**CITY OF
BLOOMINGTON**
HOUSING AND NEIGHBORHOOD DEVELOPMENT

BHPC MEETING PACKET

Thursday October 12, 2023

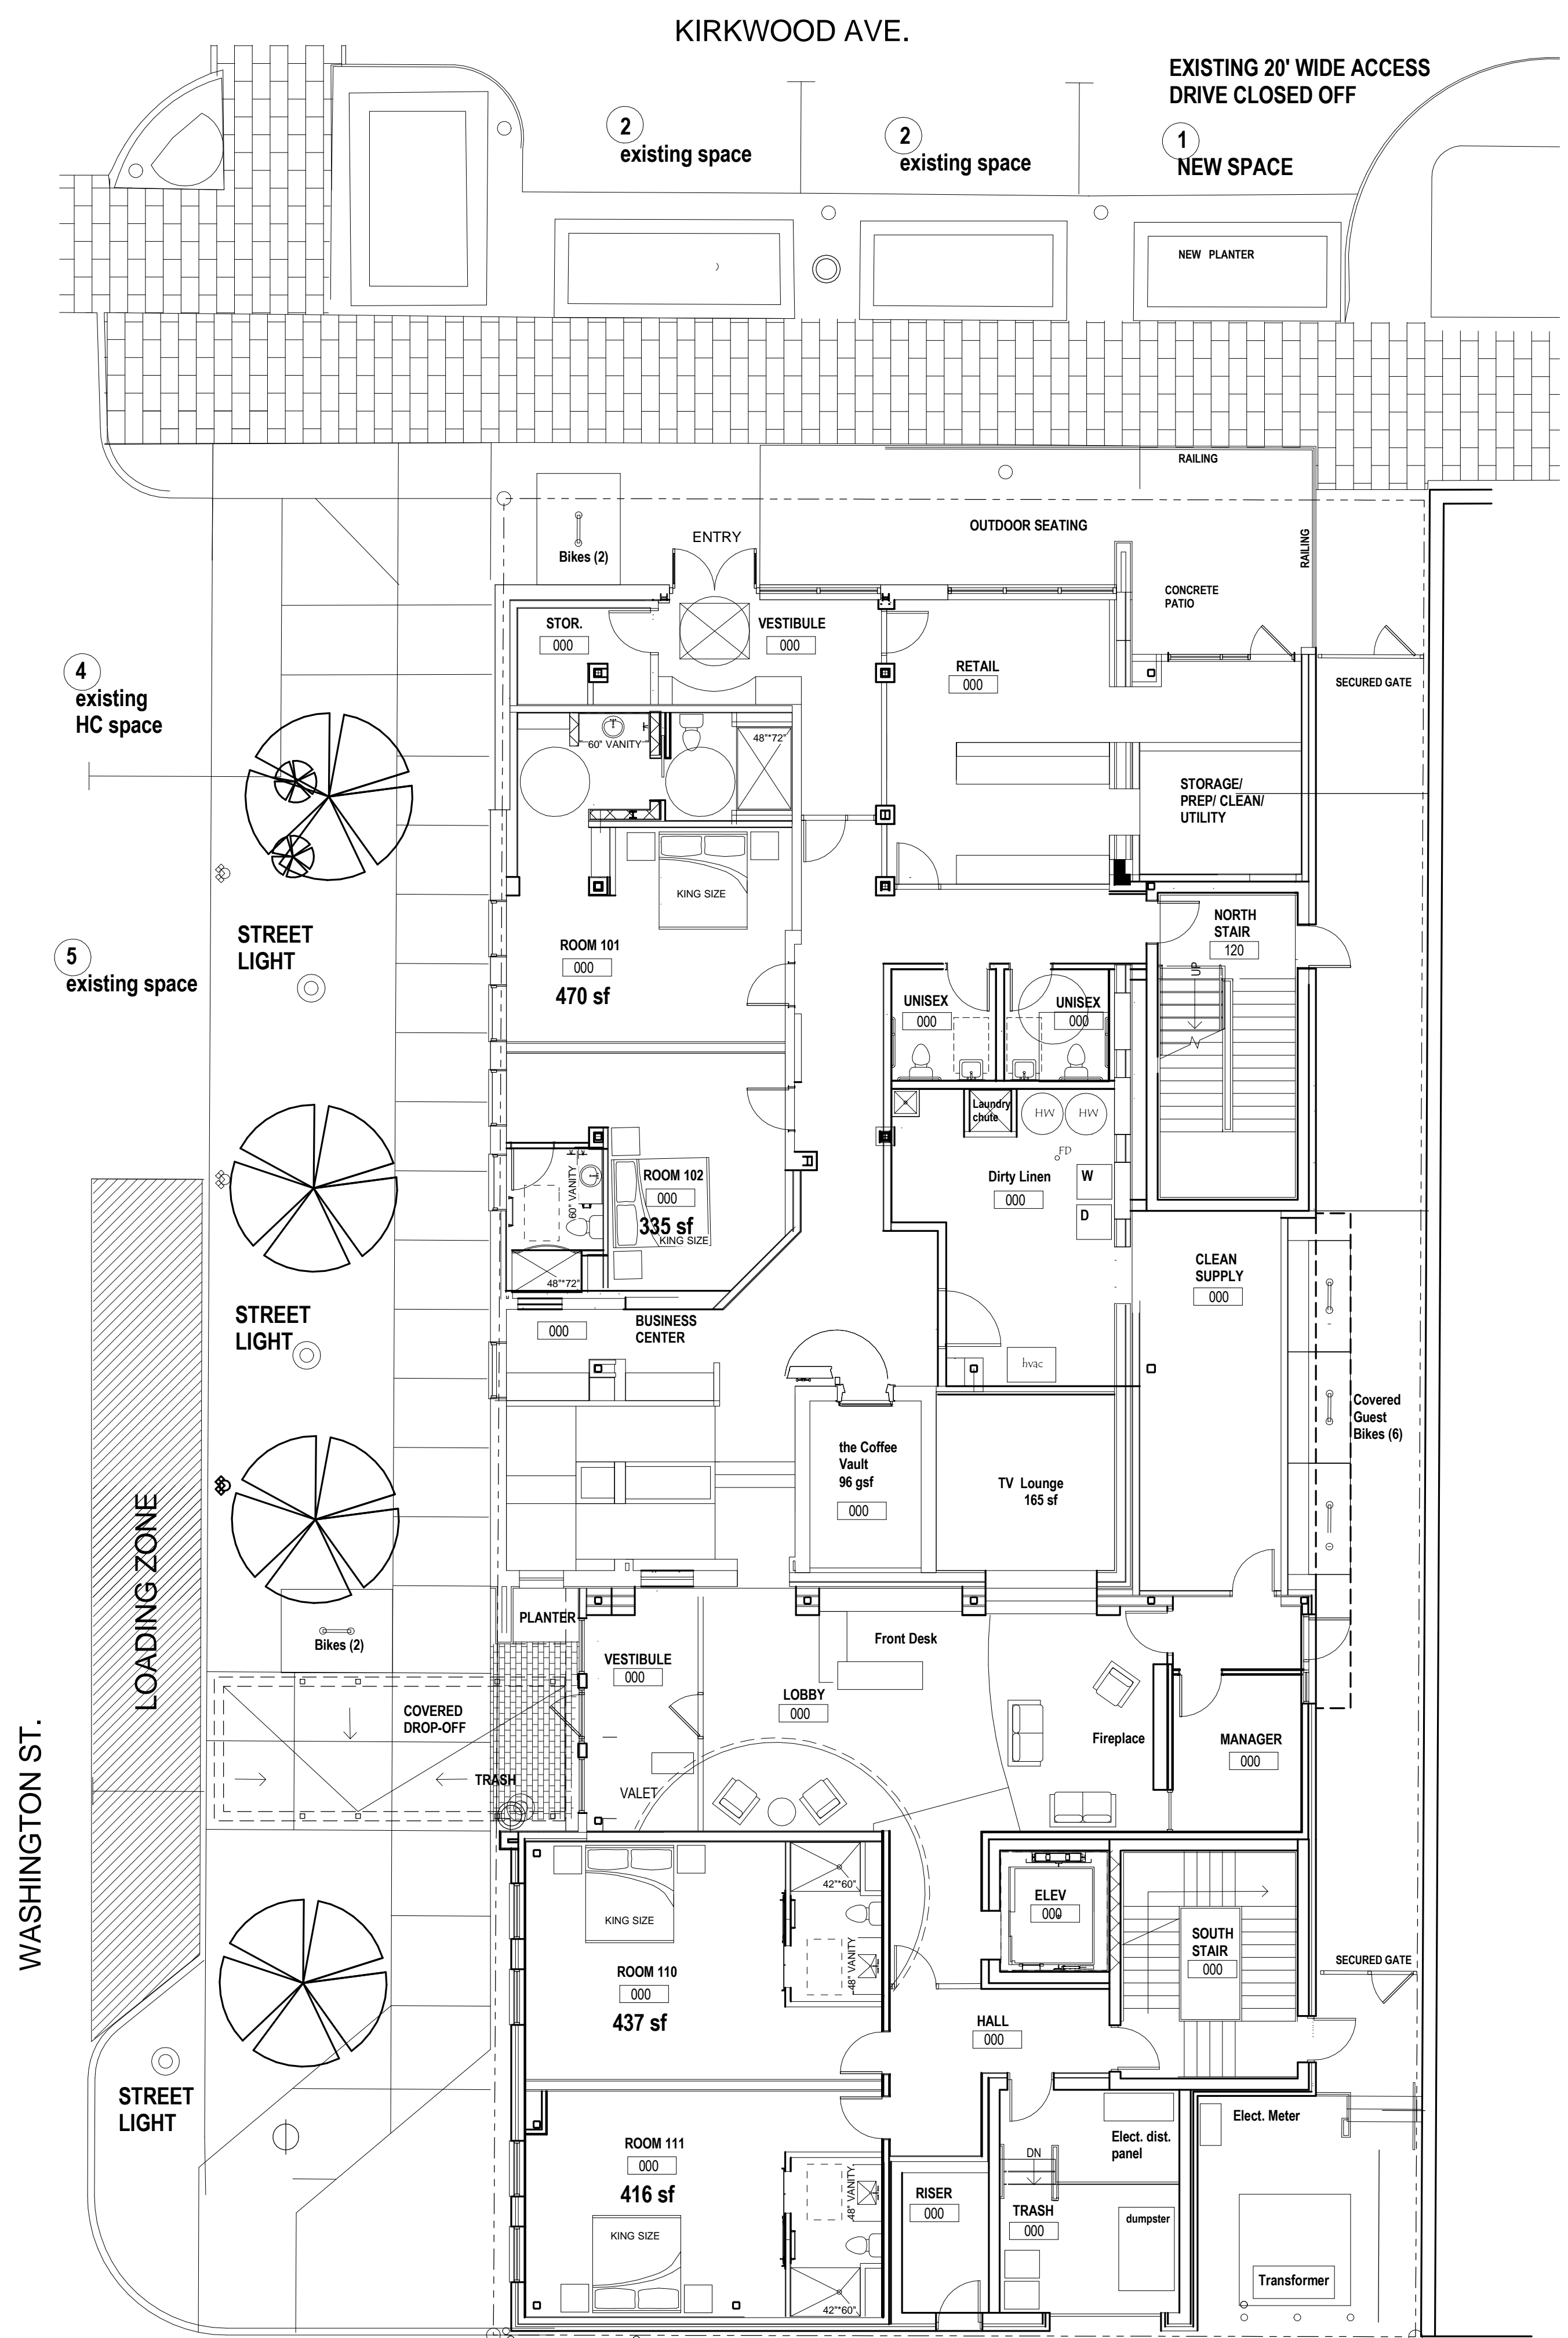
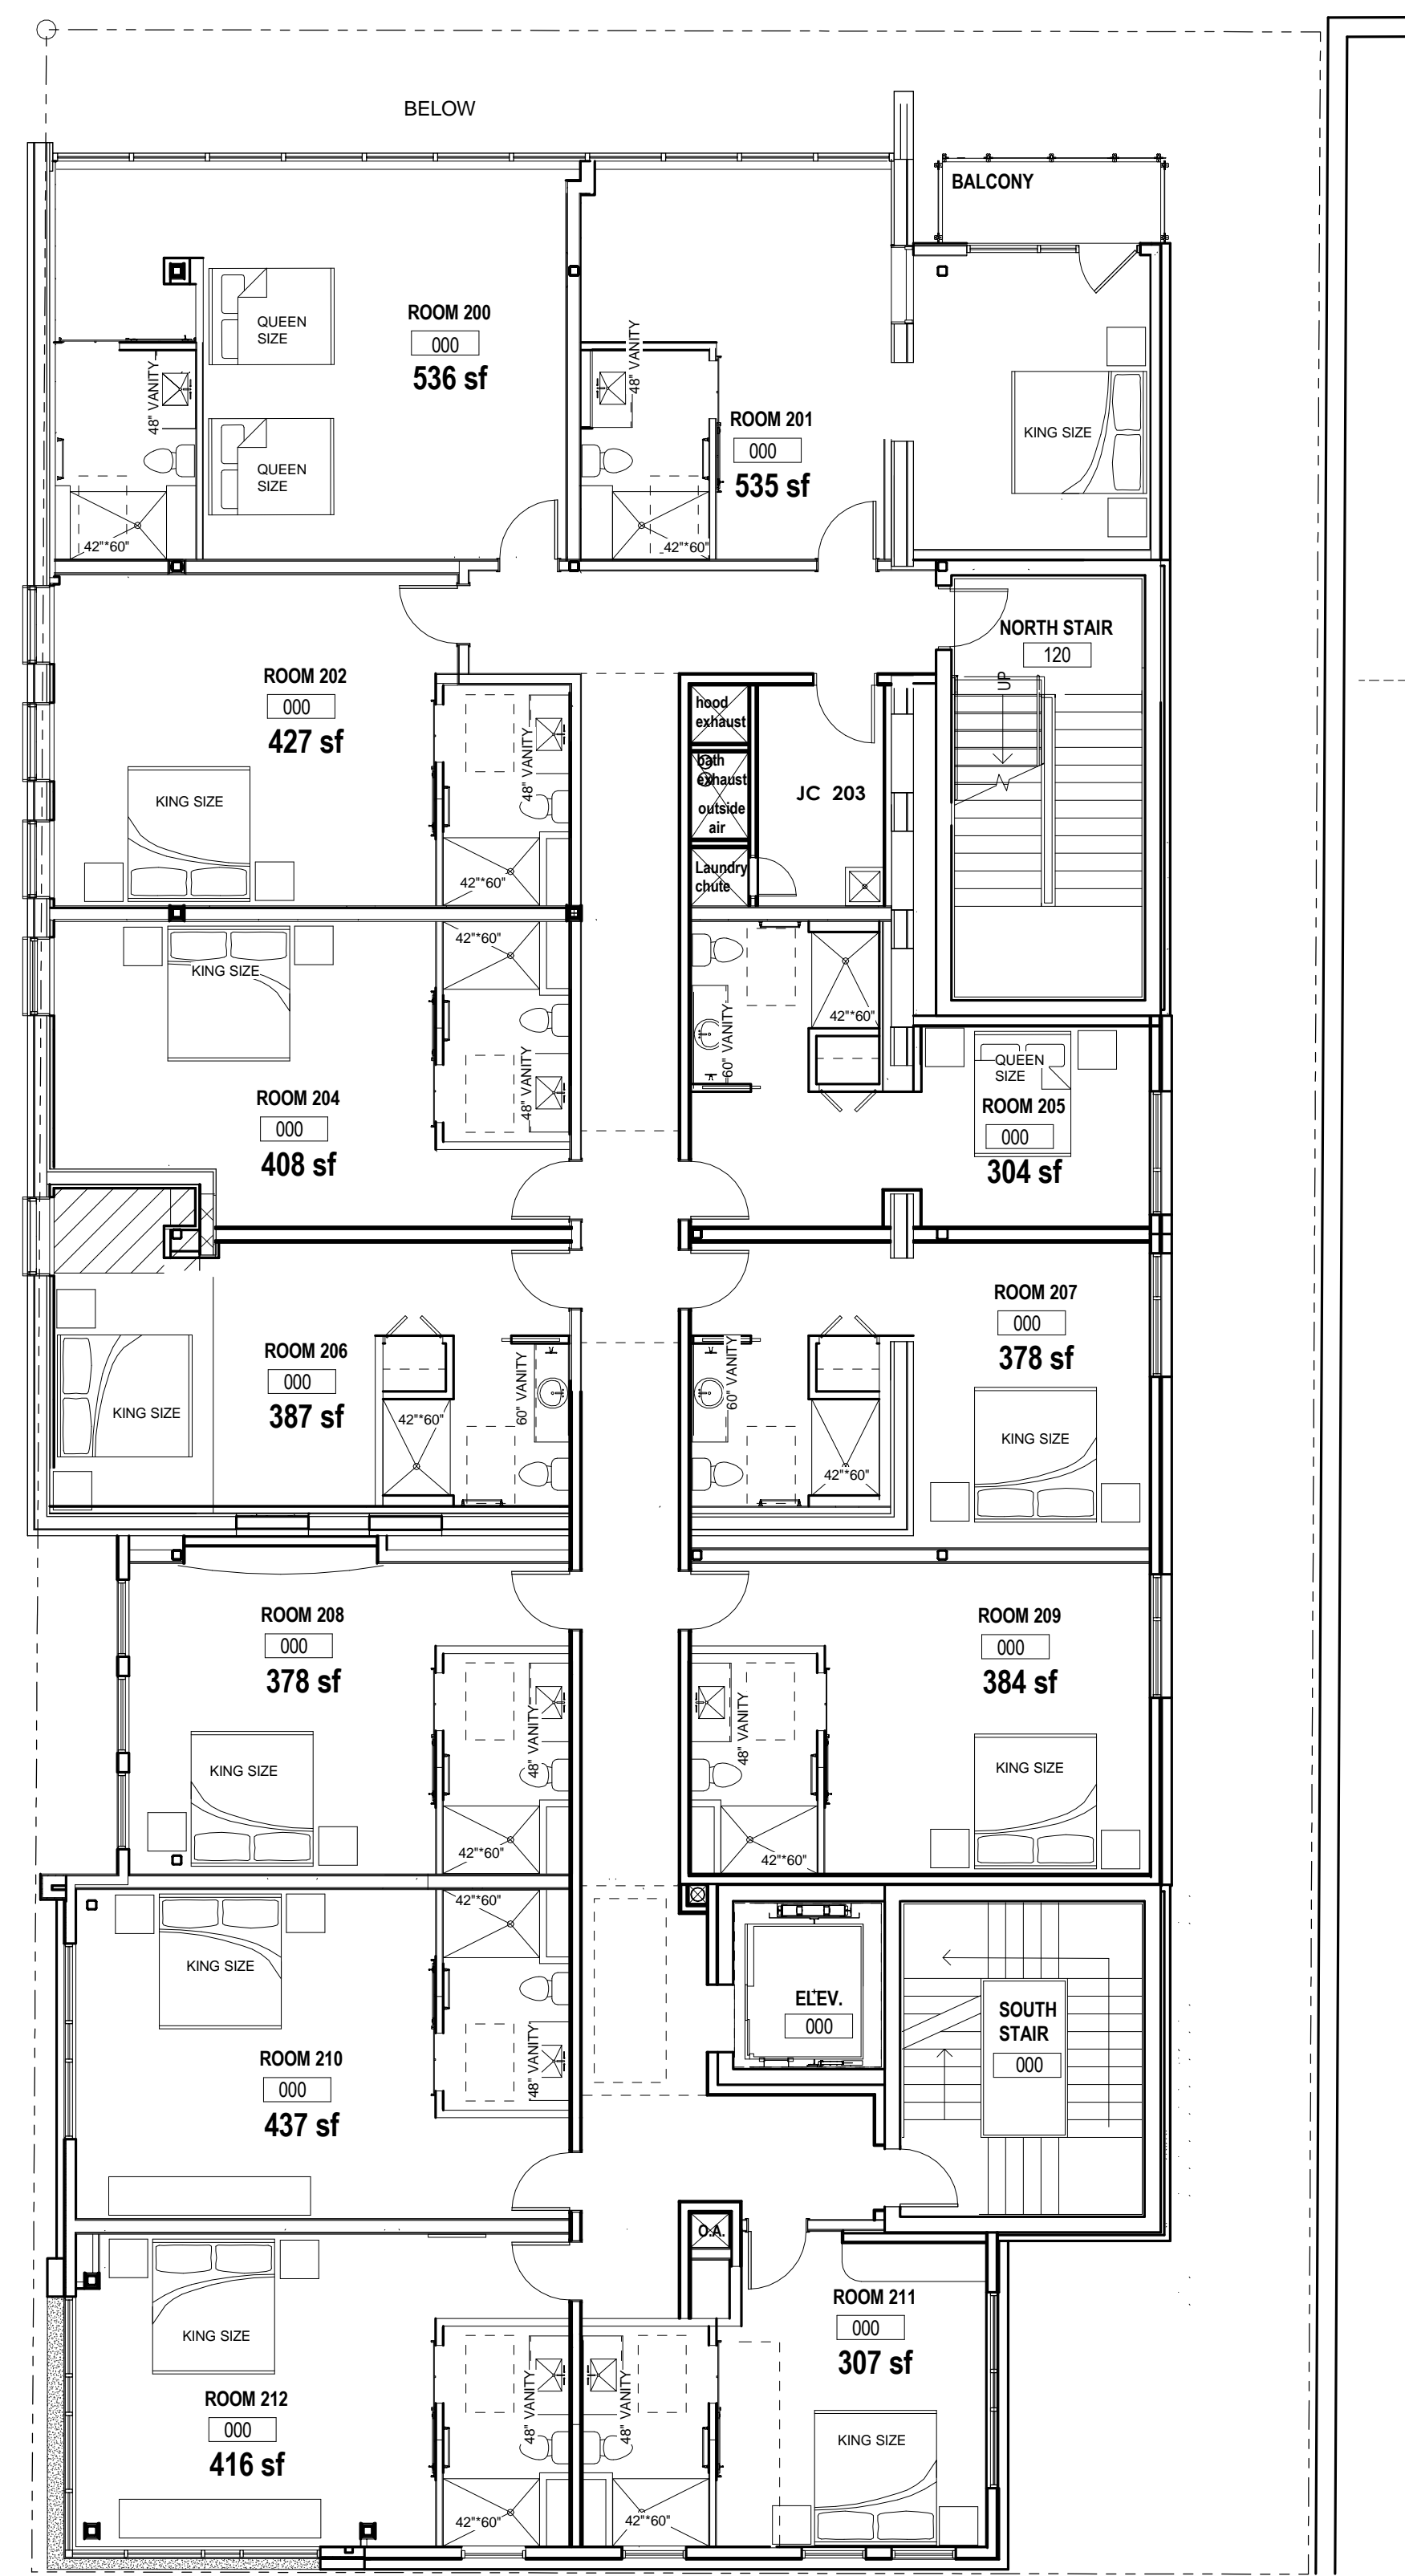
The updated renderings/ drawings include the following edits:

1. Front railing for outdoor seating area along Kirkwood (north elevation) has been simplified to a top and bottom rail with vertical standards 5' oc.

2. The Curtain wall window frame on Kirkwood (north elevation) has been noted as being replaced with a new curtain wall frame in the same pattern/ spacing and the same anodized aluminum finish.

6. South façade, brick wall, we have added a simple recessed panel reflective of the window zone above to add relief to the brick wall along the alley.

CHRIS VALLIAN T
 346 S. BUCKNER ST
 53-08-05-110-018-000-009
 SITE & FLOOR PLAN

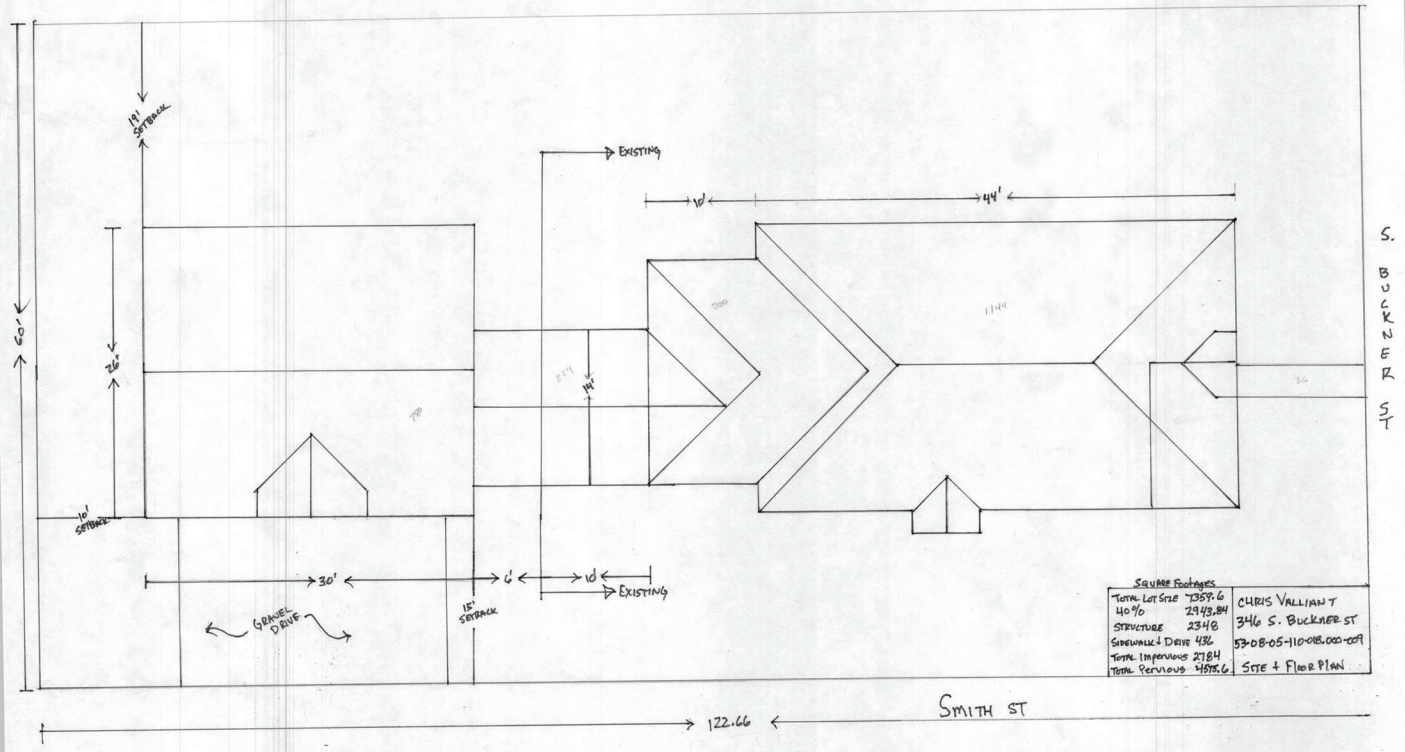
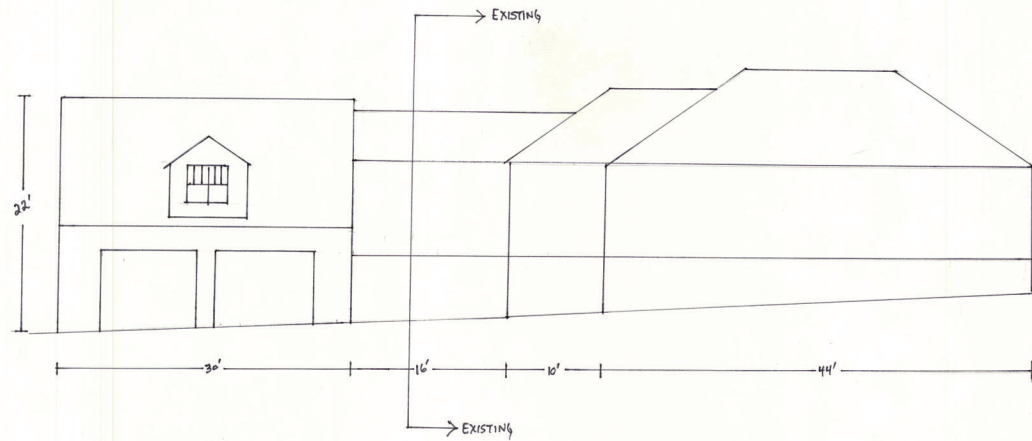
CONSTRUCTION SUBCOMMITTEE COMMENTS:

As you all may know, since this is a corner lot (Buckner and Smith), per our guidelines both those street views are considered public-way facades. The new structures face Smith Ave.

As far as the garage and the covered porch/breezeway, for me (and possibly for members of the HPC) it would be helpful to have a more detailed elevation/rendering of the Smith Ave. façade that reflects the written description. Right now we have an overhead elevation with rooflines and a very generalized south elevation lacking most of the defining details. It's hard for me to reach a conclusion about appropriateness when I can't see how the newly covered porch would interact with the breezeway and garage. In addition, there is a grade change from porch downward to garage. I believe the porch is elevated over a basement walk-out, and the point of access from there to the garage is not clearly defined in the elevations provided.

Any additional illustrations would be welcome.
